File: 101856.007(2) – Rev0

**Re: Geotechnical Site Investigation - Eugene Road Bridge Replacement
Addendum #1 – Revised Foundation Recommendations
West Nipissing, Ontario**

This letter provides Addendum #1 for additional geotechnical foundation recommendations, as requested by Planmac, to support the revised bridge replacement design, and should be read in conjunction with our original report as referenced above.

GENERAL ARRANGEMENT

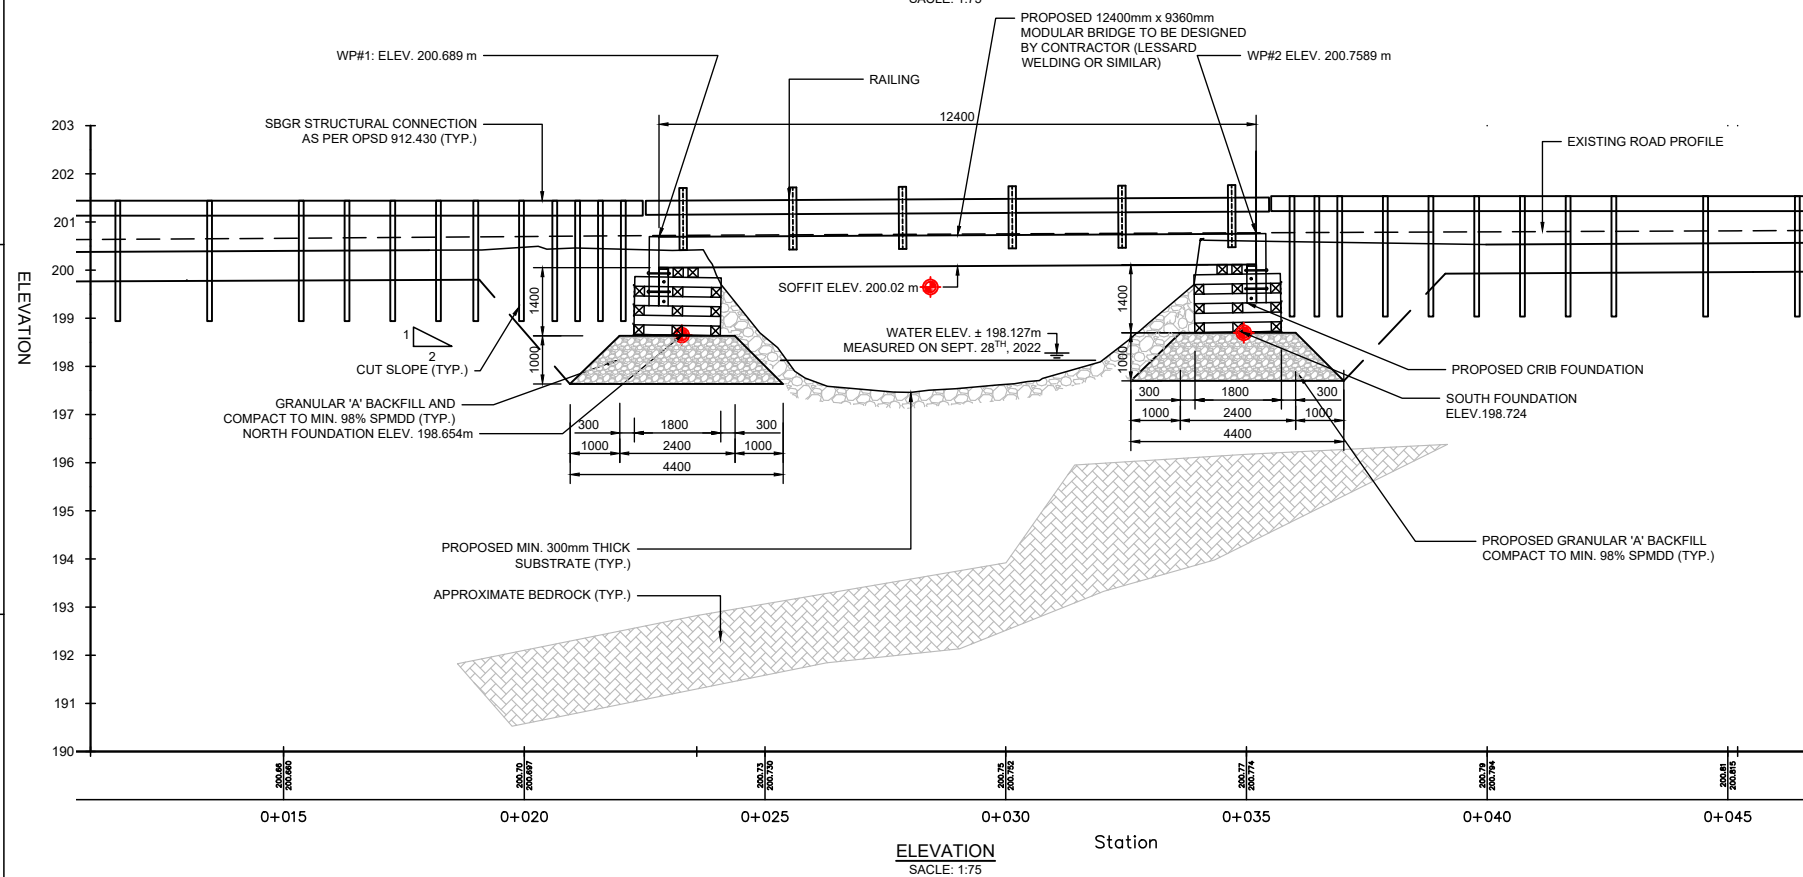
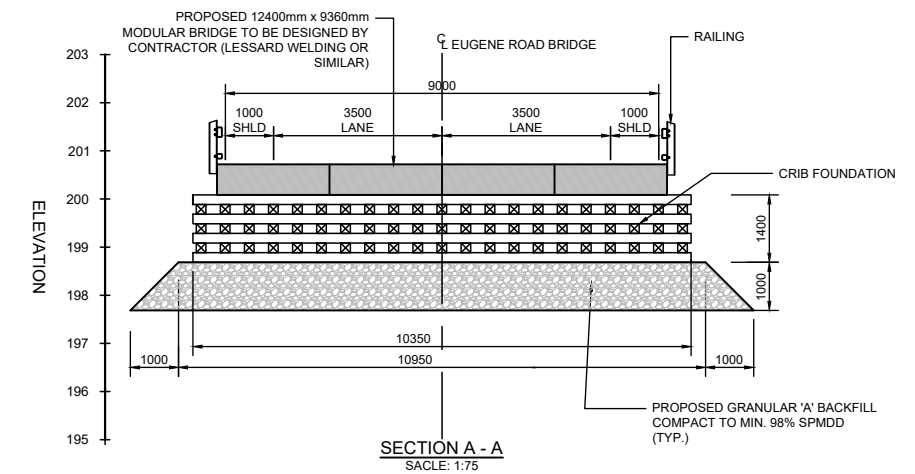
Since the time of GEMTEC’s initial reporting, the project design has been revised to comprise of an unpaved, prefabricated modular bridge structure supported by timber cribs founded on 1 m thick granular pads. Details of the revised foundation design are presented on drawing “General Arrangement” prepared by Planmac for contract number 2023-014, revised 2023-11-16, and are attached following the text of this letter. Based on a review of the attached drawings and discussions with the project team, GEMTEC understands the following:

- The timber cribs will be founded on 1 m thick granular pads at an elevation (El.) of about 198.7 m. The undersides of the granular pads are proposed to be at about El. 197.7 m.
- The granular pads will extend beyond the timber cribs by at least 300 mm in all direction at the top of the pads, and will slope down and away at a maximum inclination of 1 horizontal to 1 vertical (1H:1V).

- The timber cribs and modular bridge structure have a required bearing resistance of 80 kPa at the top surfaces of the granular pads and are capable of tolerating up to 50 mm of total settlement.
- The final ground surface on the creek side of the timber cribs will be sloped at a maximum inclination of 3H:1V to the creek edge and will be stabilized to minimize erosion and provide cover to the granular pads, including a suitable geotextile (i.e., Terrafix 270R or equivalent) between the granular pad and any erosion protection materials.

Timber crib footings with dimensions of approximately 1.8 m by 10.4 m, bearing on a minimum 1 m thick granular pad, constructed within the undisturbed native soils at about El. 198.7 m (underside of granular pad at about El. 197.7 m) may be designed using a factored Ultimate Limit State (ULS) geotechnical resistance of 100 kPa (based on a resistance factor of 0.5), and an unfactored Serviceability Limit State (SLS) geotechnical reaction of 80 kPa (for a total maximum settlement of 50 mm and an anticipated maximum differential settlement of about 40 mm). The granular pad should consist of Granular A material placed in maximum 300 mm loose lift thicknesses and compacted to a minimum 98 per cent SPMDD, and should extend beyond the footprint of the timber cribs as described above.
